ASSESSMENT REPORT

THE DAN LAND MP 06_0031 MOD 4

This report is an assessment of a request to modify the Concept Plan and Project Approval (MP 06_0031) for a residential subdivision at 290 and 302 Minmi Road, Fletcher in the Newcastle local government area.

Figure 2: Approved subdivision layout (note: Stage 10 subject of this current modification application in **RED**) (Source: Proponent)

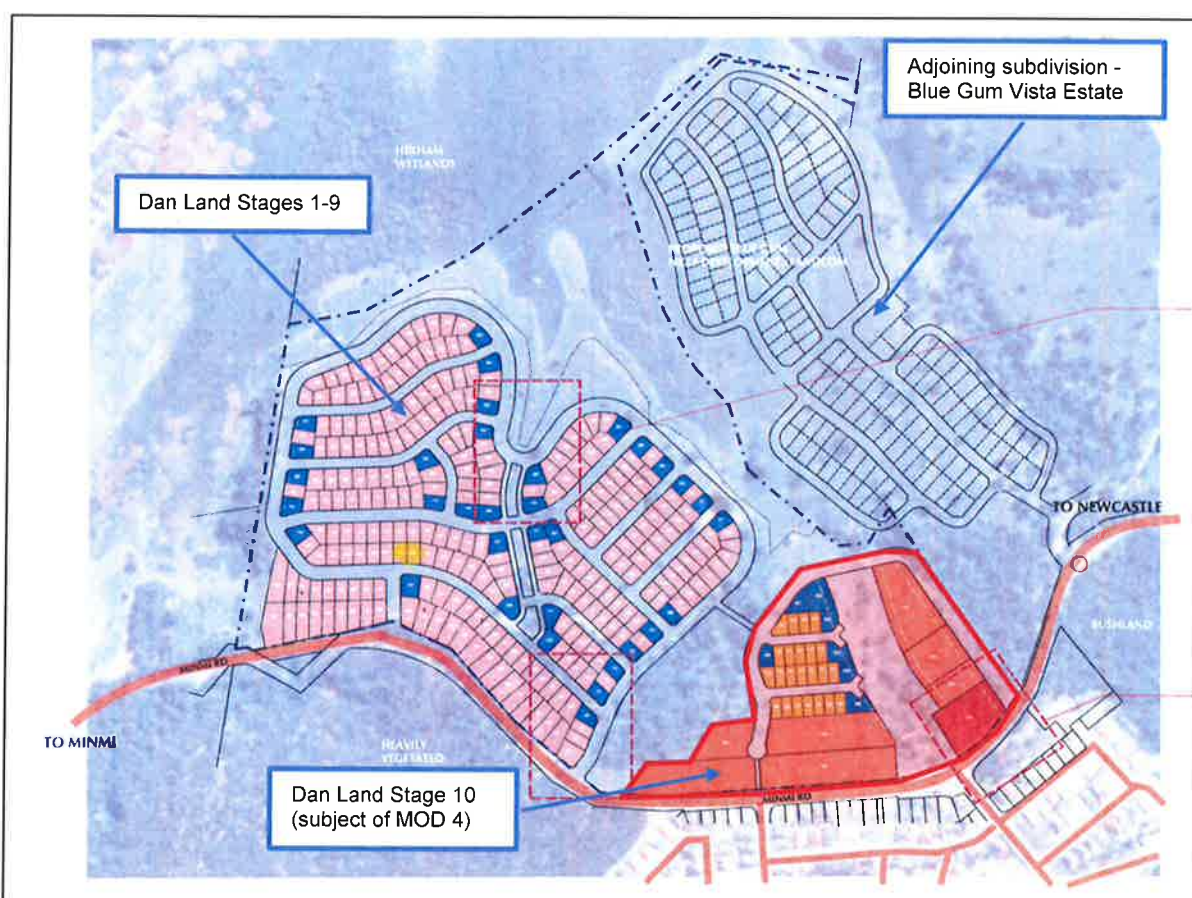
One public submission raised concern regarding increased traffic that would be generated throughout the adjoining stages of the estate as a result of the road network connection to Brookfield Avenue. The RtS confirms the connection between Stage 10 and the remainder of the estate (via 'Road No. 3') was always intended as part of the subdivision design and was approved as part of the Concept Approval. Further, Stage 10 will have its own connection to Minmi Road that will ensure residents will not be required to travel through other stages of the estate to access the wider public road network. The Department considers this issue does not warrant the need for amendments to be made to the road network layout and connections.

As a part of its assessment of MOD 1 the Department imposed Condition B10 (b) and (c) in the Project Approval. These changes were required to ensure Stage 10 of the subdivision better connected with the development on the southern side of Minmi Road. The Department has considered the revised road network connections and access arrangements for Stage 10 and is satisfied the requirements of Condition B10 (b) and (c) are addressed as part of this modification. Further, the Department considers the proposed loop road results in improved design outcomes, rather than the creation of cul-de-sac roads. The Department also considers the requirements of Condition B2 of the Concept Approval (which outlines the same requirements as Condition B10(b)) have been addressed.

To address Council's submission on the modification request and the RtS, the Department recommends the Concept Approval be amended by deleting Condition B2.

Figure 6: Indicative lot typologies (Source: Stage 10 Development Guidelines)

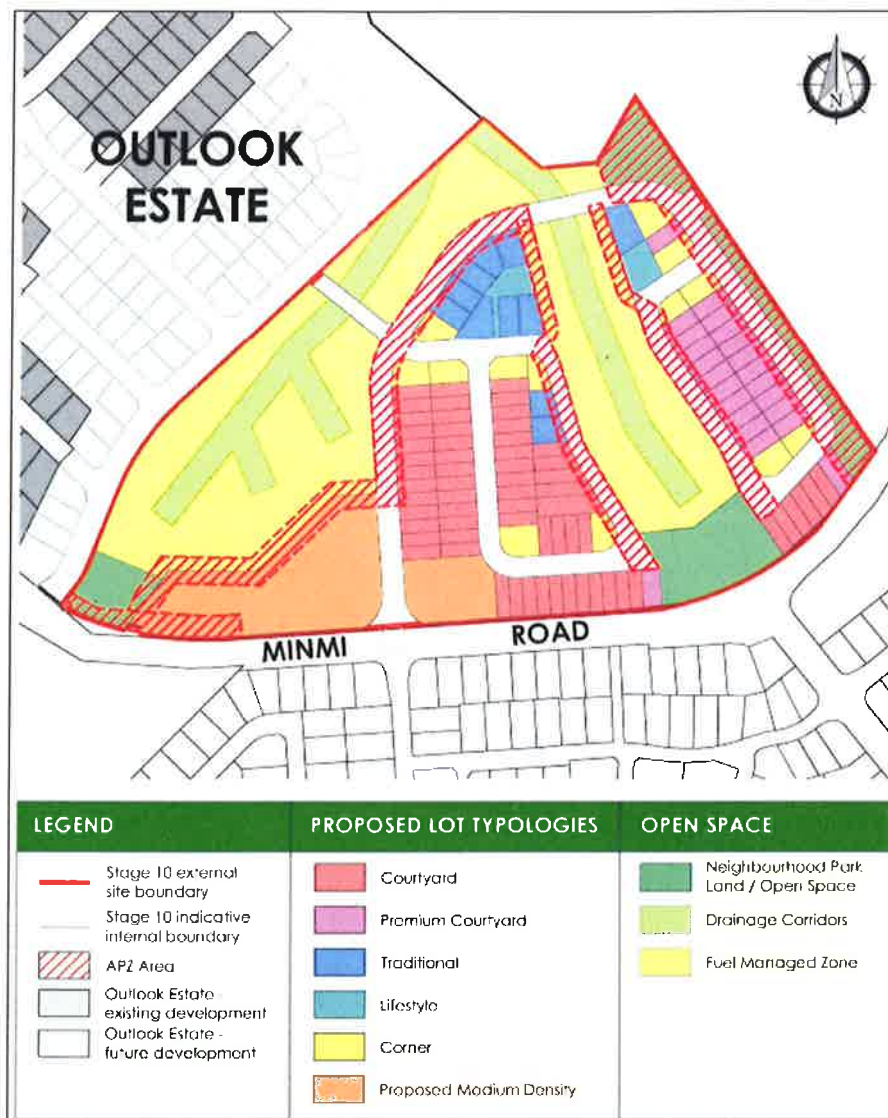
Two public submissions objected to the proposed small lot housing as it would detract from the existing makeup of the subdivision, place further strain on the capacity of Minmi Road and increase the risk of traffic accidents.

The LPS incorporates certain land use directions outlined under the *Newcastle 2030 Community Strategic Plan* and guides Council with decision-making for growth across the Newcastle LGA. The Department considers the proposed development of small lot housing within Stage 10 is appropriate for the site and is consistent with the LPS. In particular, the Strategic Directions for Residential Lands (Section 4.1.2 of the LPS) provides for the provision of small lot subdivision located near commercial centres, such as the existing Neighbourhood Centre located at the corner of Minmi Road and Britannia Boulevard in Fletcher (located adjacent to the site). Further, the provision of small lot housing improves affordable housing options and allows for greater housing choice and diversity, as required under the LPS.

Accordingly, the Department considers the proposed modification to the subdivision layout of Stage 10 and inclusion of lots less than 400m² is acceptable. The Department is also satisfied the increase in residential density across the entire Dan Land subdivision from 400 to 413 lots in total, representing a minor increase of 3% overall, would result in negligible impacts. Residential density is discussed further in **Table 1** (refer **Section 7.3**).
